RECALL 17V-047: DRIVER'S FRONT AIR BAG MODULE – PRIOR PARTS REPLACEMENT

This Service Information bulletin replaces SI B65 02 17 **dated March 2017**

RE: Recall 17V-047: Driver's Front Air Bag Module B65 02 17

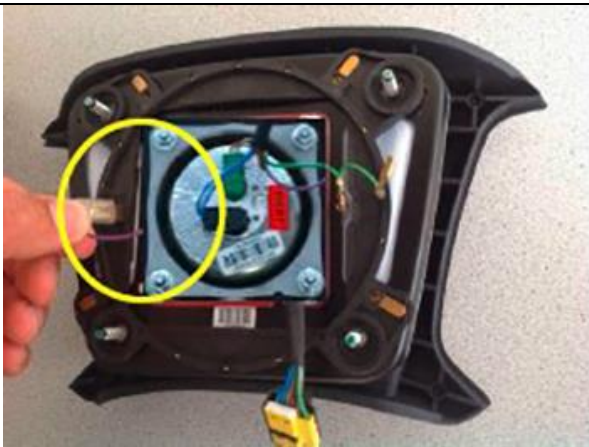
On vehicles with a basic steering wheel, the horn ring must be removed from the new part. To do so, proceed as follows:

<p>1. Remove horn ring.</p> <ul style="list-style-type: none">• Unplug the connector for the grounding cable (see the green arrow in the figure)• Remove the nuts (see the blue mark in the figure, Torx 55).
	<ul style="list-style-type: none">• Take off the horn ring, making sure that the springs remain in place.• Remove the horn contact plate.• Separate components after disassembly:<ul style="list-style-type: none">1 - Air bag module2 - Horn ring3 - Horn contact plate4 - Torx nuts

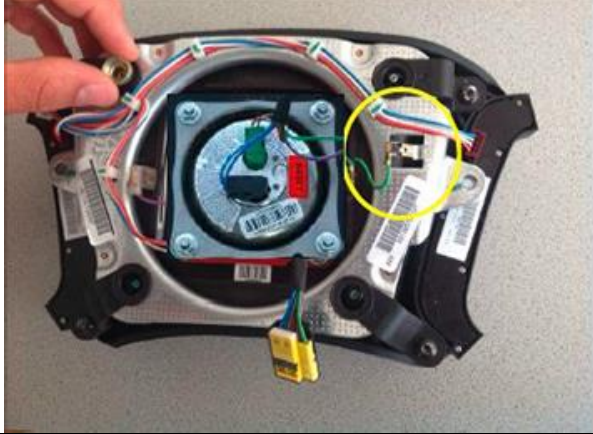
2. Prepare the new air bag module and pull off one of the two labels with the barcode and serial number of the air bag module. This must be stuck onto the horn ring **after** installation.
